SUBJECT: Responses to the New Mexico Environment Department *Notice of Disapproval: Mixed Waste Landfill Corrective Measures Implementation Report, January 2010 Sandia National Laboratories, EPA ID NM5890110518, HWB-SNL-10-005*

**Document title:** Responses to the New Mexico Environment Department  
"Notice of Disapproval: Mixed Waste Landfill Corrective  
Measures Implementation Report, January 2010"

*This document represents a revision to the January 2010 Mixed Waste Landfill Corrective Measures Implementation Report in response to the New Mexico Environment Department Notice of Disapproval dated May 20, 2011.*

Figure 2-5  
Schematic MWL-MW4 PVC Well Casing and Protective Surface Casing Extension Diagram

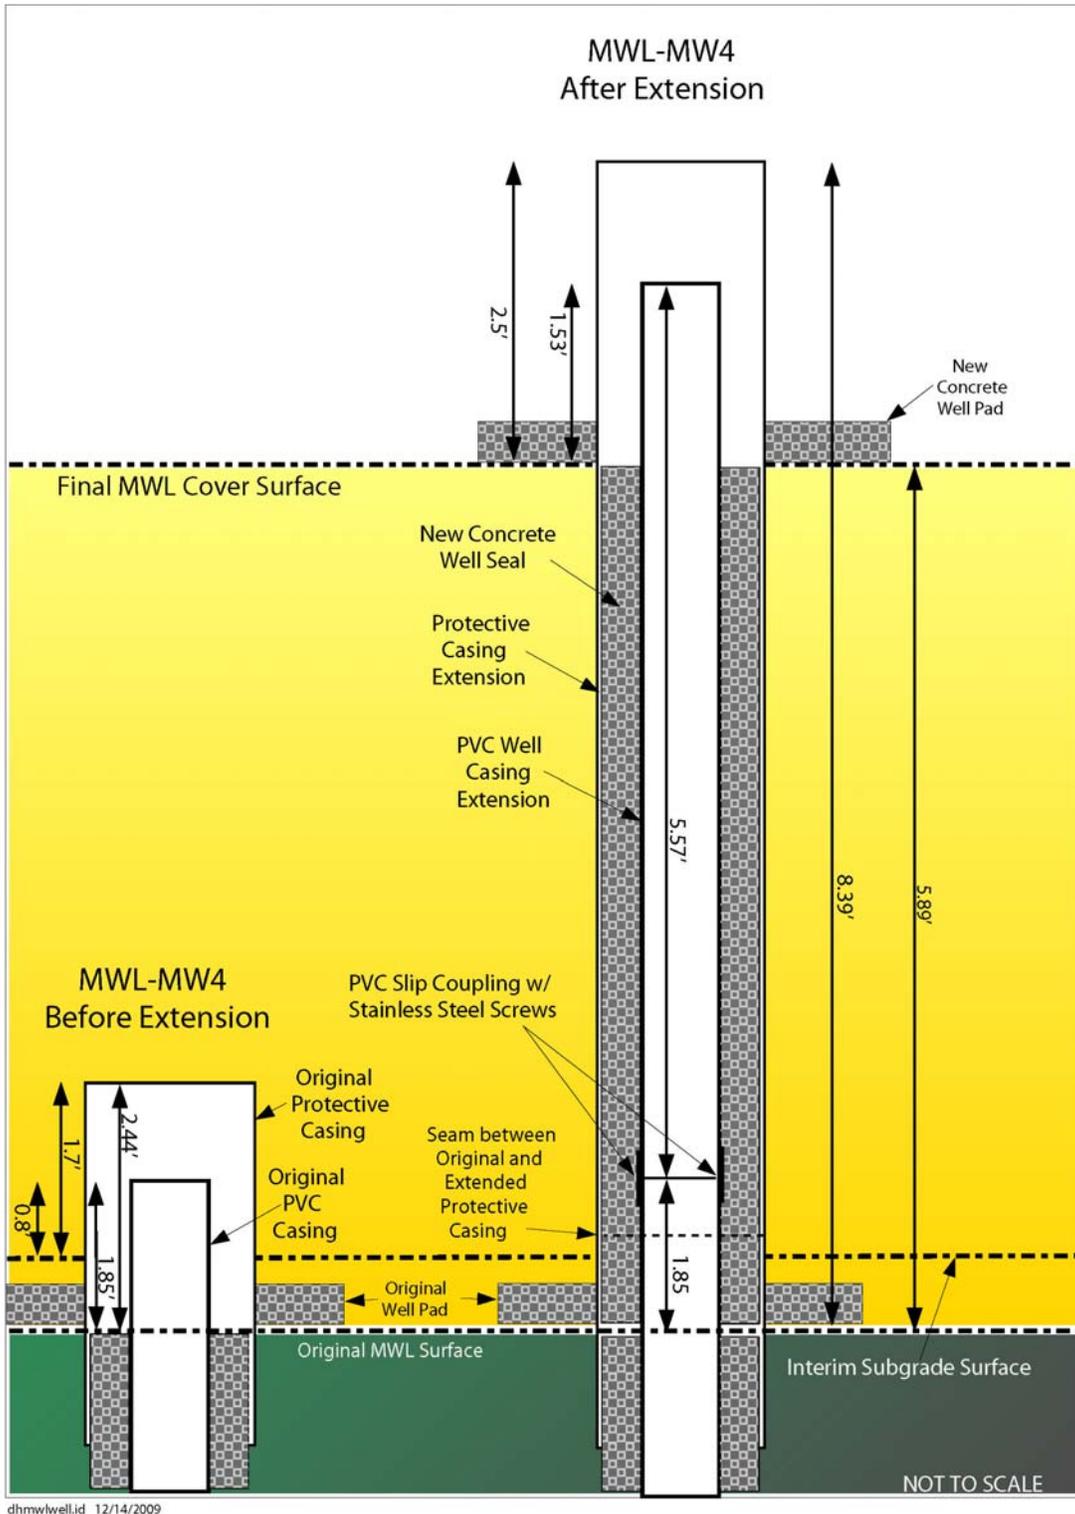
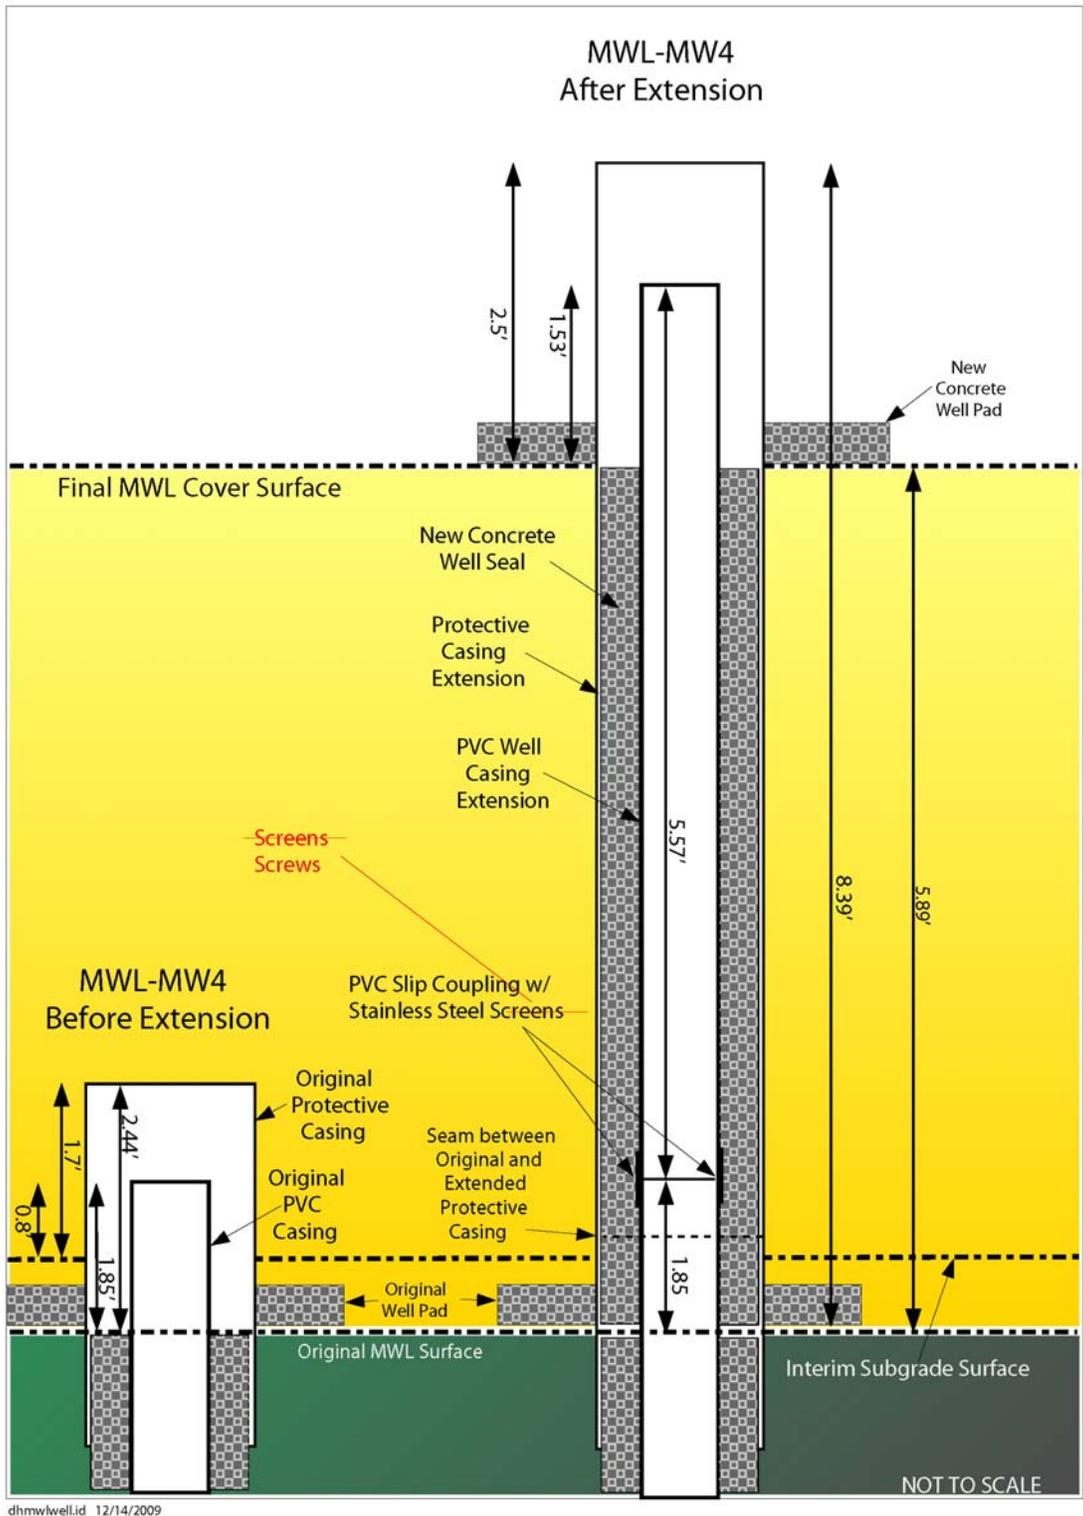
**CQA Report, Attachment 8, Figure 2-5, center of figure: "PVC Slip Coupling w/ Stainless Steel Screens" should read "PVC Slip Coupling w/Stainless Steel Screws".**

**Response:** The error in Figure 2-5 of Attachment 8 in the CQA Report (Appendix A of the CMI Report, Volume 2), has been corrected. The associated revision to the CQA Report is tracked in Table 1 and documented in redline-strikeout format in Attachment 1. Attachment 2 of this comment response document provides the replacement page, and the revised figure is incorporated into the electronic version of the CMI Report (January 2010, Revision 1) provided on both CDs.
